Access Compliance Report

Public Rights-of-Way

Intersection ID: 8619	Main Street: HATERAS_AV	Cross Street: JENNINGS_ST	Location: NW
ADA ID: 0C47A54364E4	Ramp Type: Perp	Initial Pass/Fail: Pass	Overall Compliance: No
Severity Score: 10			
Codes/Mitigation Info/Possible Solution		Field Measurements/Component Compliance

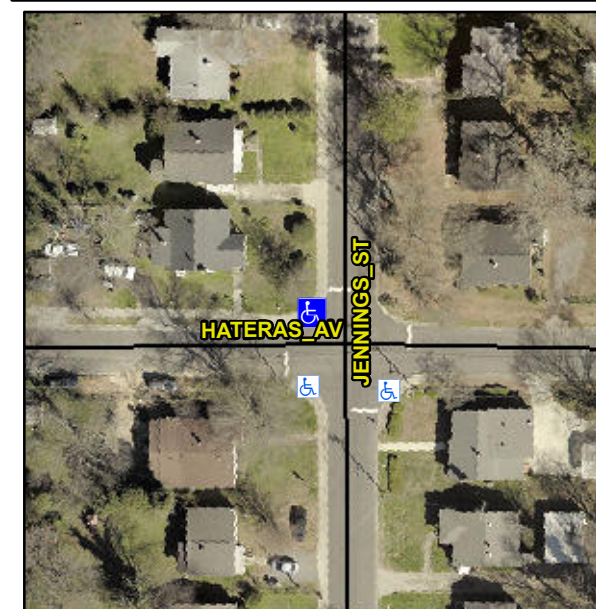
Not Found, R304.2.1, R304.2.2-Perp, R304.3.2-Para, R304.5.3

Compliance	Description	Data	Compliance	Description	Data
N/A	Ramp Length (in)	58.5	Yes	Ramp Slope (%)	6.8
Yes	Ramp Width (in)	48.0	Yes	Ramp XSlope (%)	0.8
N/A	Flare Type LT	Sloped	N/A	Flare Type RT	N/A
N/A	Flare Slope LT (%)	5.5	Yes	Flare Slope RT (%)	7.8
N/A	Flare Traversable LT?	Yes	N/A	Flare Traversable RT?	Yes
No	Landing Length (in)	N/A	Yes	DWS Provided?	Yes
No	Landing Width (in)	N/A	Yes	DWS Contrast?	Yes
No	Landing Slope (%)	N/A	Yes	DWS Length (in)	24.0
No	Landing X Slope (%)	N/A	Yes	DWS Full Width?	Yes
N/A	Landing Curb? (Y/N)	No	Yes	DWS Offset (in)	2.0
N/A	Shared Landing?	No			
Yes	Gutter Ponding?	No	Yes	Gutter Slope (%)	0.0
Yes	Gutter Lip Ht (in)	0.0	Yes	Gutter X Slope (%)	0.9
N/A	Painted X Walk1?	No	N/A	Painted X Walk2?	N/A
	X Walk 1 Direction	To S		X Walk 2 Direction	N/A
N/A	X Walk 1 Width (in)	N/A	N/A	X Walk 2 Width (in)	N/A
	X Walk 1 Slope (%)	0.9		X Walk 2 Slope (%)	N/A
	X Walk 1 X Slope (%)	1.9		X Walk 2 X Slope (%)	N/A

Remove & Replace Entire Ramp.
